**ADDENDUM NO. 01
December 11, 2023**

**Brookledge Golf Course Club House
1621 Bailey Rd.
Cuyahoga Falls, OH 44221
TC Project No.: 58A23**

DETAILS AND ISOMETRICS - PLBG

P301
DRAWING NUMBER

GREASE INTERCEPTOR DETAIL

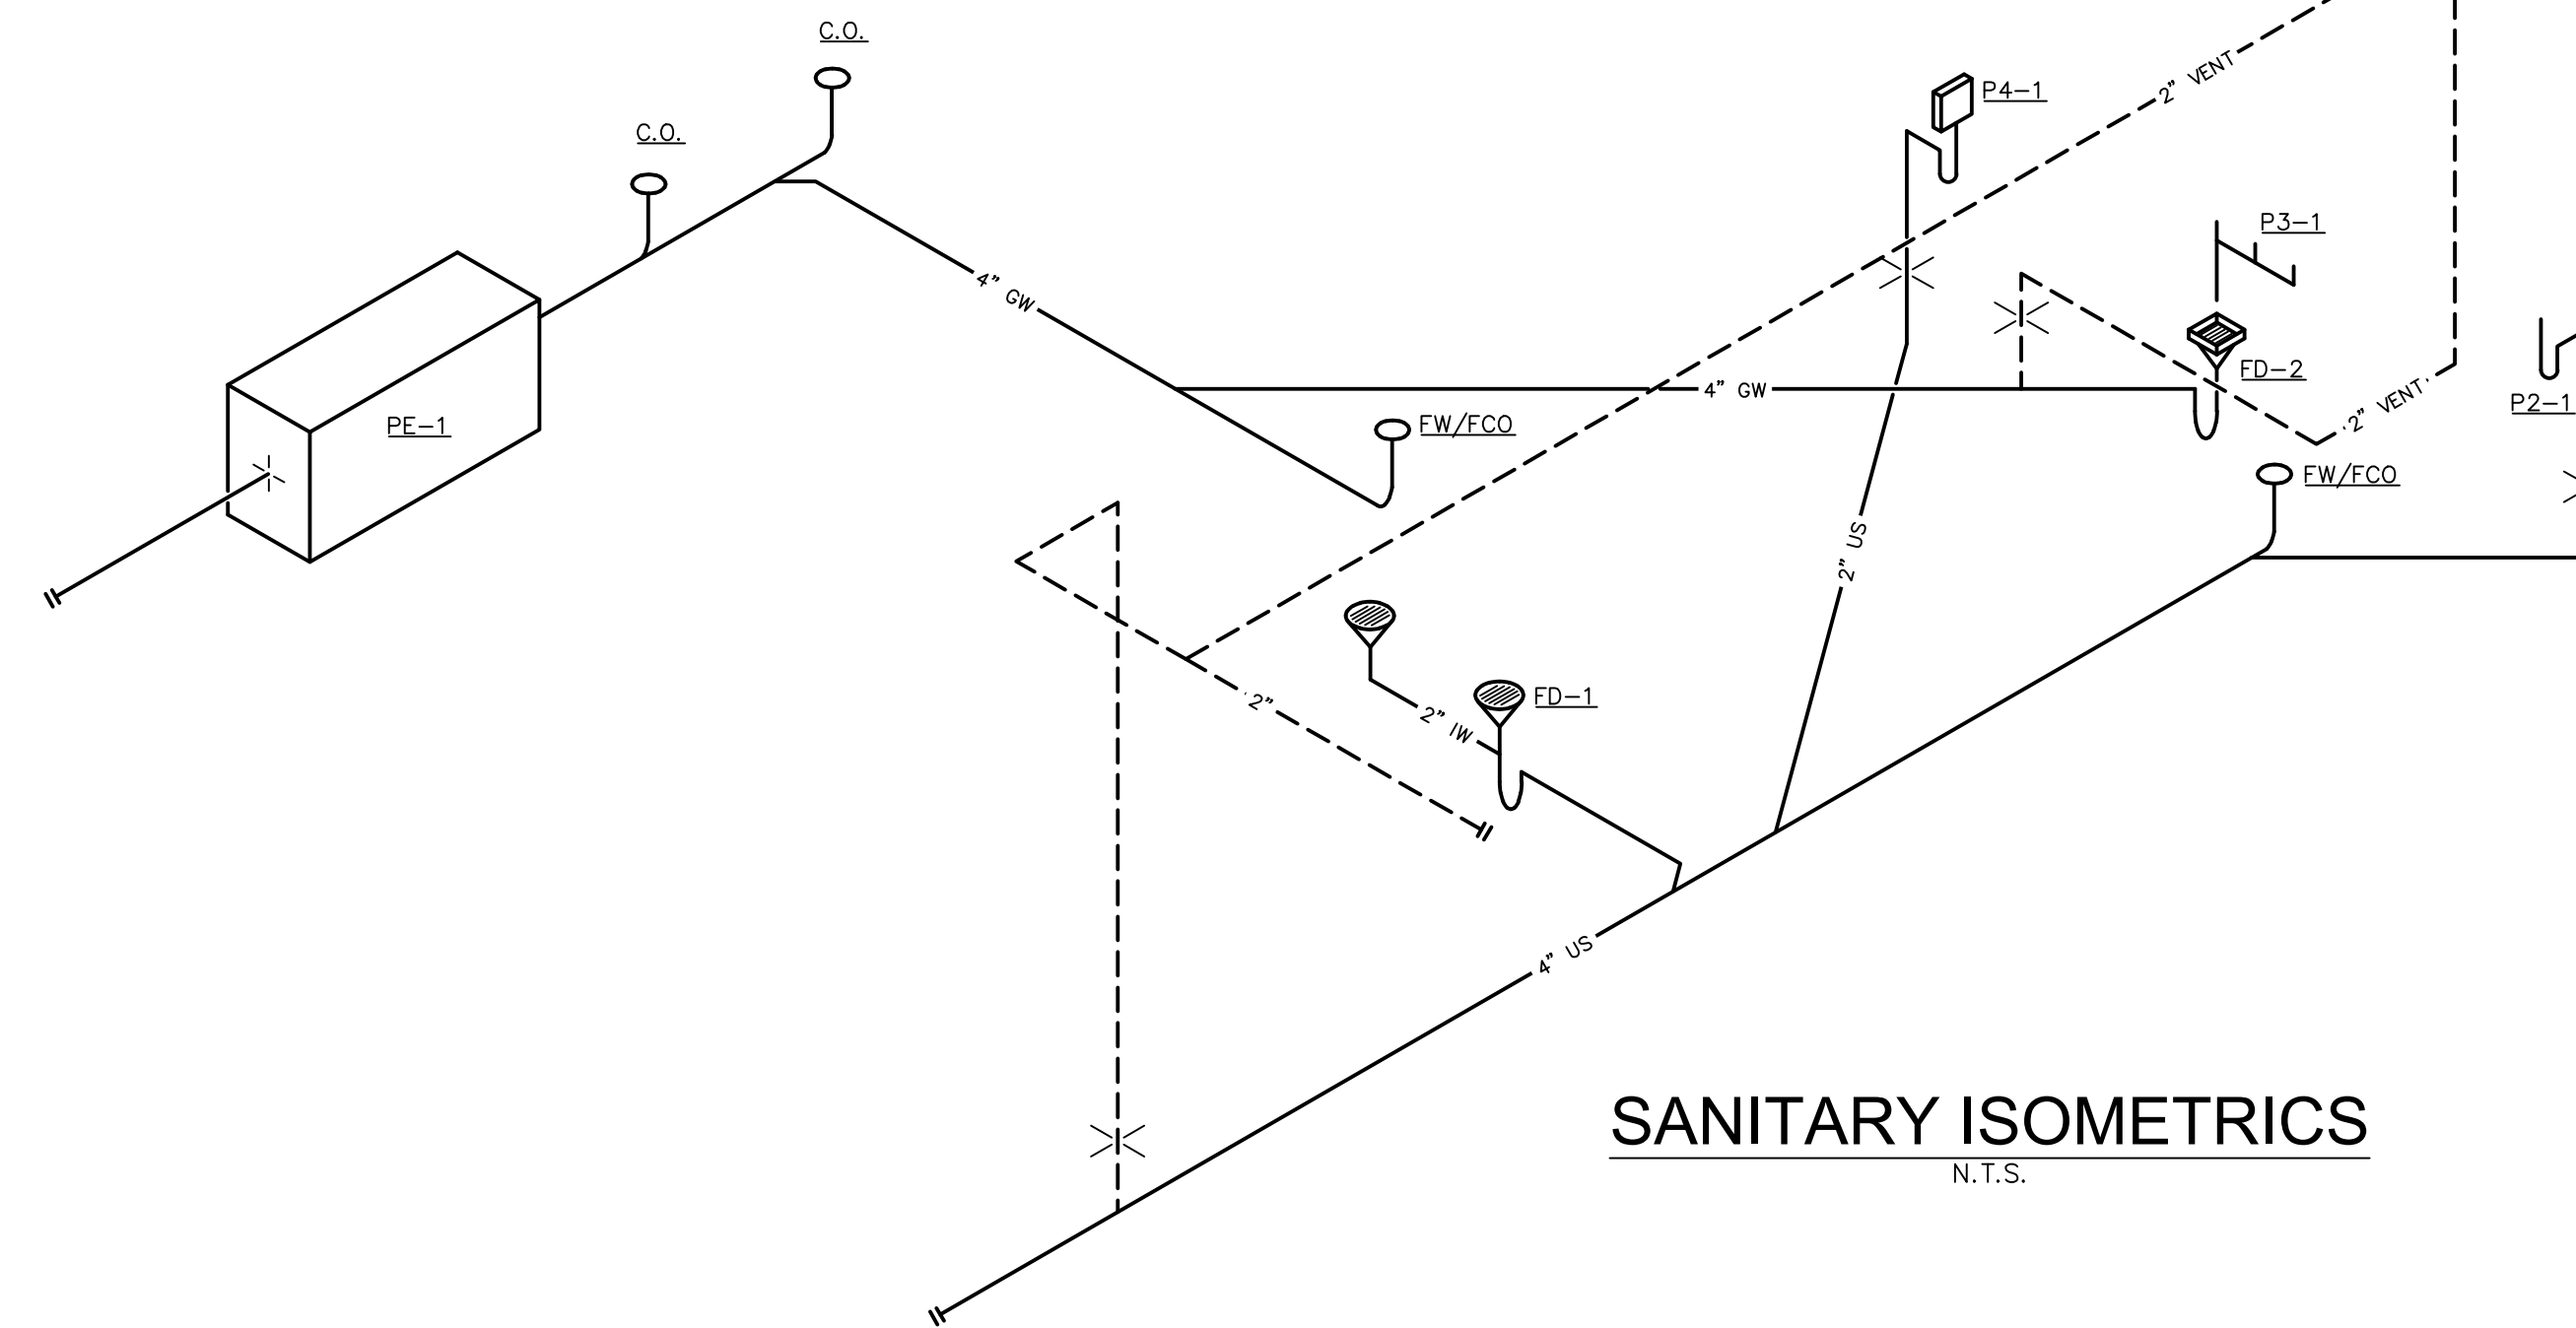
2. **Summit County normally requires a sampling port to be installed downstream of the grease trap so that they can test the effluent for grease content.**

- a. **They do not do any coating. You wouldn't normally want to install any coating until after the 28 day cure time is up. To apply this coating in the field in the winter is next to impossible. Typically we dig the hole and Mack comes with their crane truck and sets it in the hole.**

- b. **We then immediately fill it with water so that it won't float. The trap comes in two pieces and they assemble it when they drop it off. I noticed that there is no local vent or downstream vent on the trap.**

See revised detail on sheet P301.

The epoxy coating is not required. See revised detail on sheet P301.

See revised detail on sheet P301.

SANITARY ISOMETRICS

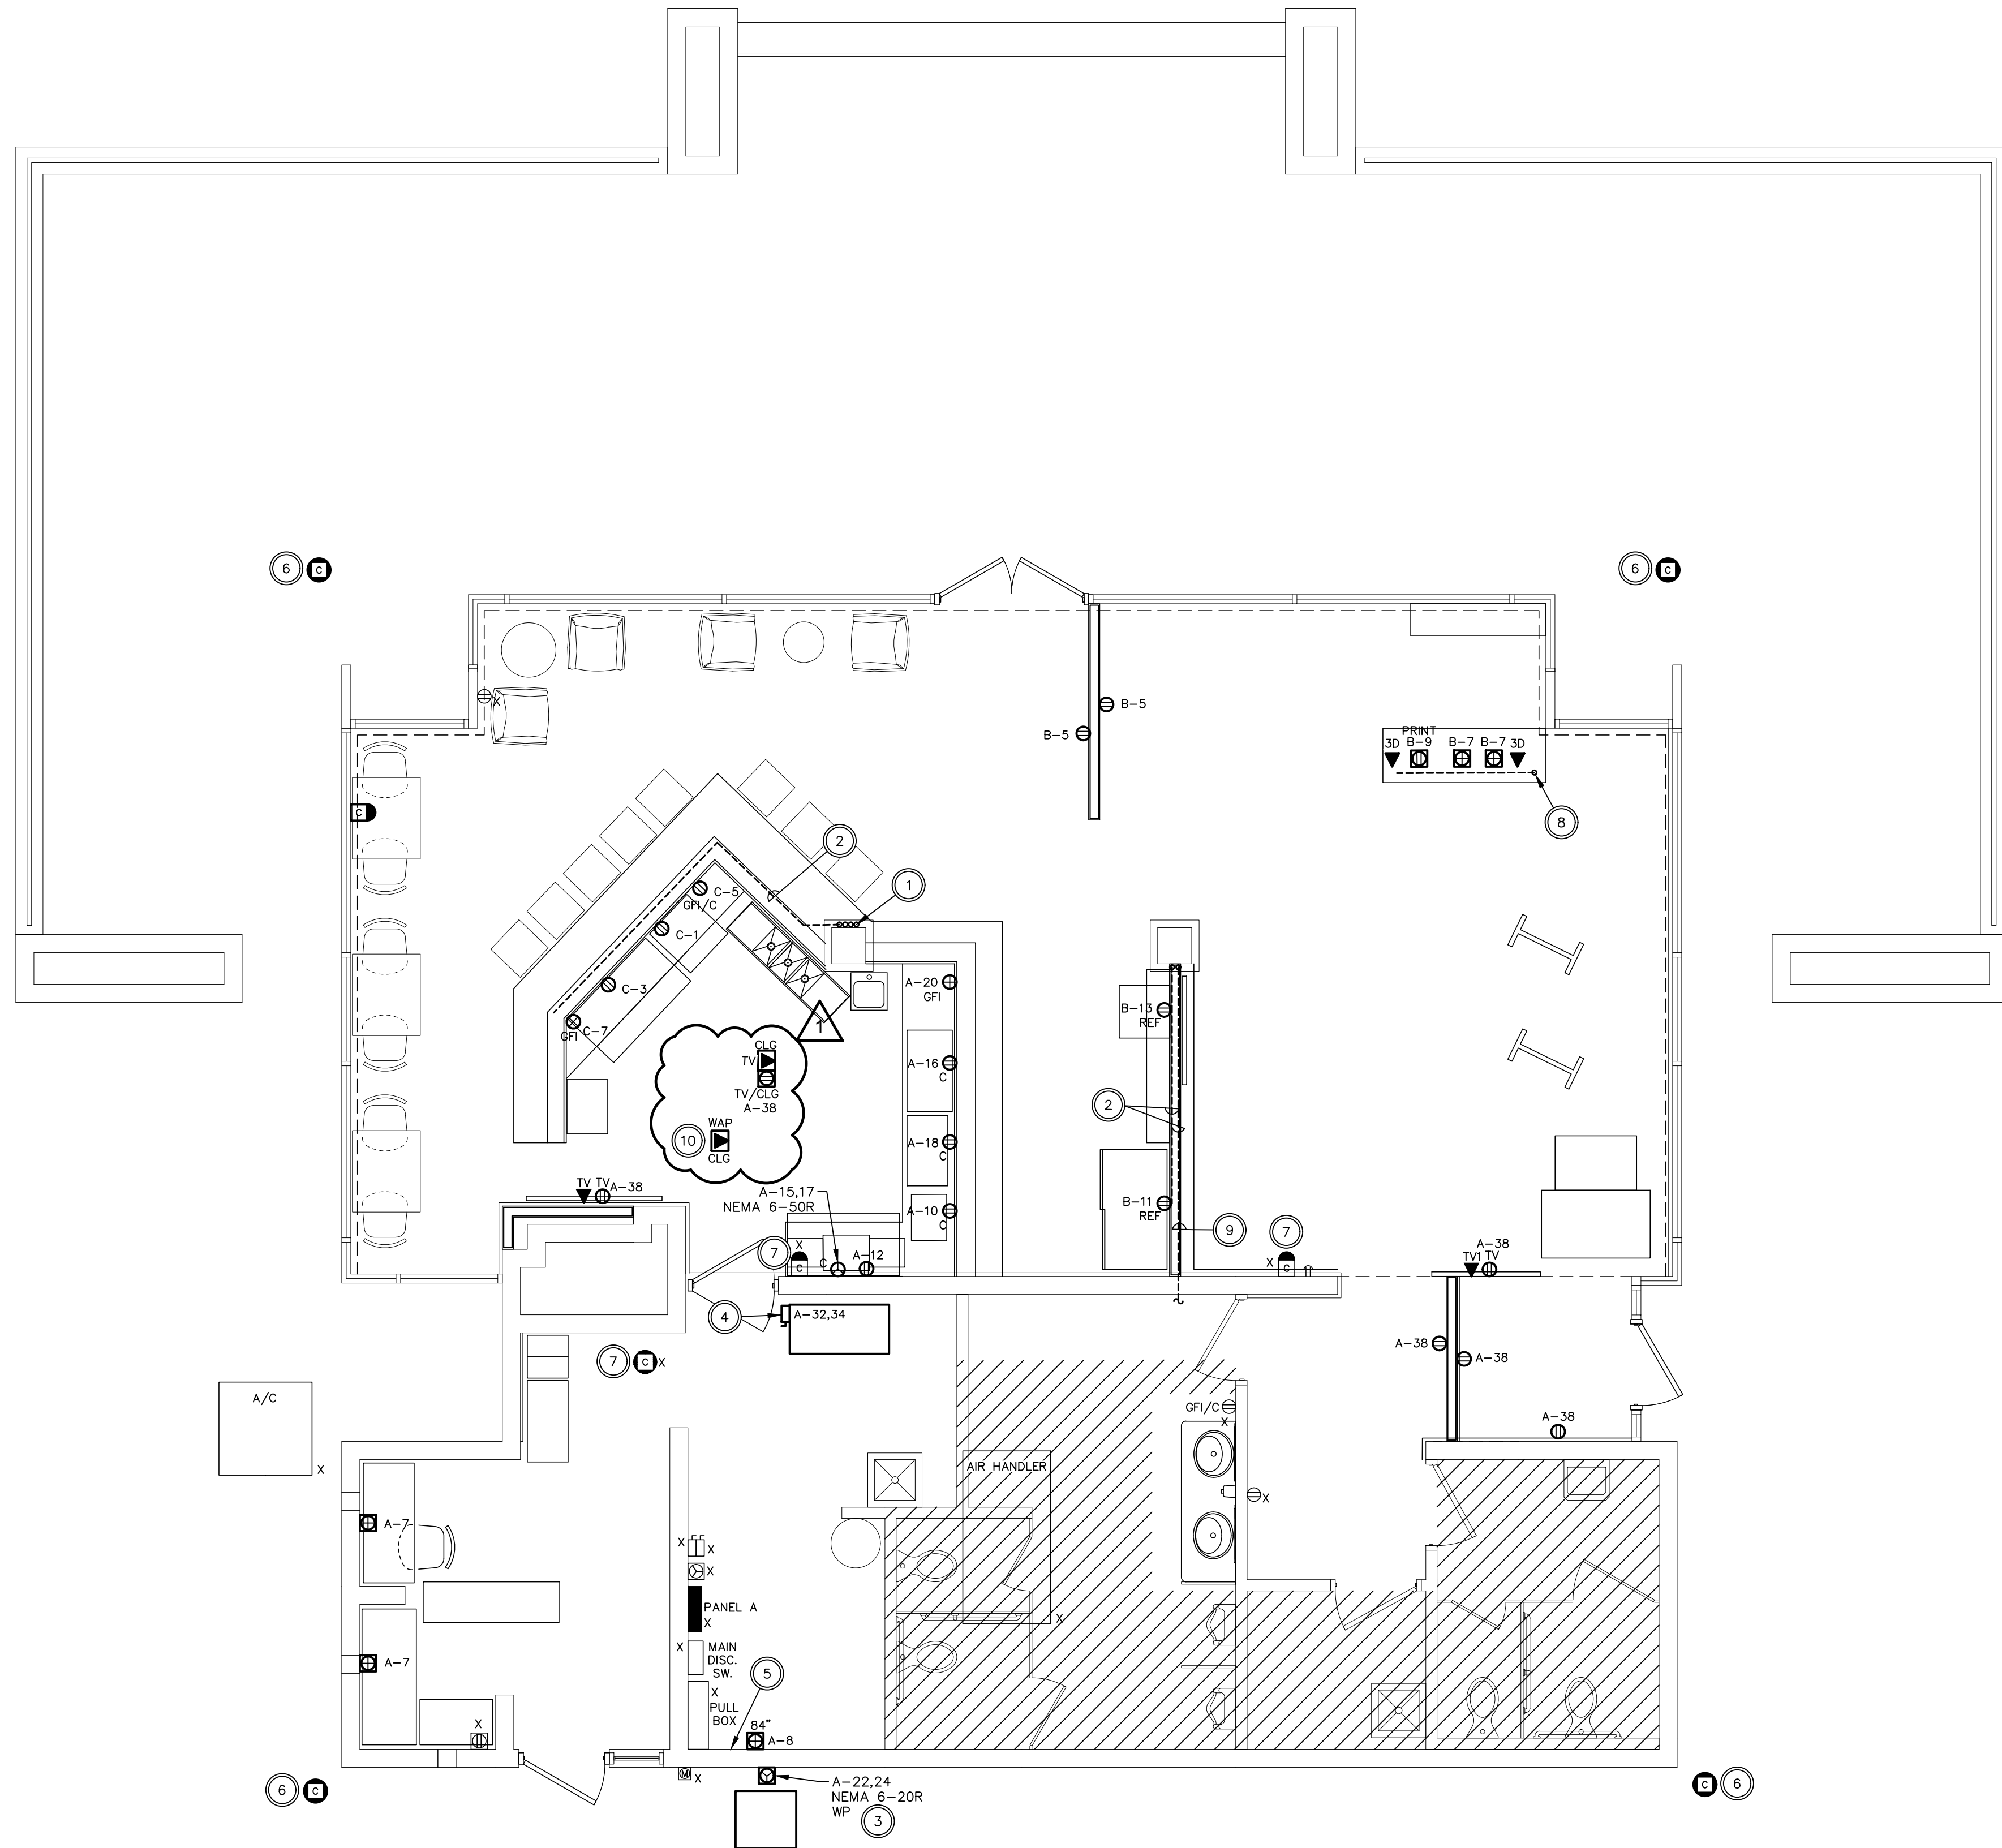
3. **The plan calls to install some flat venting at the three part sink which is not permitted by code.**

The 3-compartment sink discharges into a floor sink below with an air gap. Venting is provided to the floor sink by a 2" vent extending up from below the floor and routing horizontally below the 3-compartment sink and into the adjacent wall. The horizontal run of vent piping is routed above the flood rim of the floor sink. Please refer to coded note 8 on P201 and isometric on sheet P301 for routing layout and clarification.
